Access Compliance Report

Public Rights-of-Way

(Pedestrian Signals)

Intersection ID: N/A	Main Street:	Cross Street: N/A	Location: N/A
ADA ID: BE9AAD7D1B54	Signal Type: One Push Button-Non APS	Overall Compliance: No	Severity Score: BTN 1: N/A BTN 2: N/A No BTN: N/A
Codes/Mitigation Info/Possible Solution		Field Measurements/Component Compliance

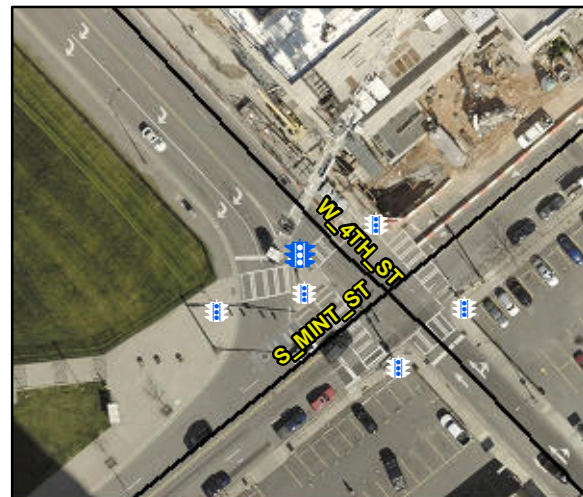
Surveyor Notes: TEXT HT 3/8

Compliance	Description	Data	Compliance	Description	Data
	Button Count	Button1	Yes	Distant to Additional Button (in)	179.0
	Additional Button Present?	Yes		Additional Button ID	C03926333457
N/A	Signal Buttons Required?	N/A	N/A	Additional Ped Posts Required	N/A
	How Many Ped Street Xings?	3		Located In An Island/Median?	Yes
N/A	B 1 Sign Present?	Yes	N/A	B 2 Sign Present?	N/A
Yes	B 1 Sign Purpose?	Yes	N/A	B 2 Sign Purpose?	N/A
No	B 1 Sign Lettering & Contrast?	No	N/A	B 2 Sign Lettering & Contrast?	N/A
Yes	B 1 Parallel To XWalk?	Yes	N/A	B 2 Parallel To XWalk?	N/A
Yes	B 1 PAR to Button?	Yes	N/A	B 2 PAR to Button?	N/A
Yes	B 1 PAR to XWalk?	Yes	N/A	B 2 PAR to XWalk?	N/A
Yes	B 1 Clear Floor Space?	Yes	N/A	B 2 Clear Floor Space?	N/A
N/A	B 1 FWD Approach?	Yes	N/A	B 2 FWD Approach?	N/A
N/A	B 1 FWD Approach Constrained?	No	N/A	B 2 FWD Approach Constrained?	N/A
No	B 1 FWD Approach Reach (in)	11.0	N/A	B 2 FWD Approach Reach (in)	N/A

N/A	B 1 FWD Approach Width (in)	N/A	N/A	B 2 FWD Approach Width (in)	N/A
N/A	B 1 FWD Approach Obstruction?	Yes	N/A	B 2 FWD Approach Obstruction?	N/A
N/A	B 1 FWD Approach Obstruction Dist (in)	11.0	N/A	B 2 FWD Approach ObstructionDist (in)	N/A
N/A	B 1 PARA Approach?	Yes	N/A	B 2 PARA Approach?	N/A
N/A	B 1 PARA Approach Constrained?	No	N/A	B 2 PARA Approach Constrained?	N/A
No	B 1 PARA Approach Reach (in)	11.0	N/A	B 2 PARA Approach Reach (in)	N/A
N/A	B 1 PARA Approach Width (in)	N/A	N/A	B 2 PARA Approach Width (in)	N/A
N/A	B 1 PARA Approach Obstruction?	Yes	N/A	B 2 PARA Approach Obstruction?	N/A
N/A	B 1 PARA Approach Obstruction Dist (in)	11.0	N/A	B 2 PARA Approach ObstructionDist (in)	N/A
No	B 1 Clear Floor Space Slope (%)	8.2	N/A	B 2 Clear Floor Space Slope (%)	N/A
Yes	B 1 Clear Floor Space XSlope (%)	0.3	N/A	B 2 Clear Floor Space XSlope (%)	N/A
N/A	B 1 PAR Slope (%)	4.2	N/A	B 2 PAR Slope (%)	N/A
Yes	B 1 Height (in)	40.0	N/A	B 2 Height (in)	N/A

Possible Solutions: Remove & Replace Sign. Provide Push Button Extension. Remove and Replace Clear Space.

PROW/ADA: R410.6, R404.2, R404.3, R406.2, R404.7.3
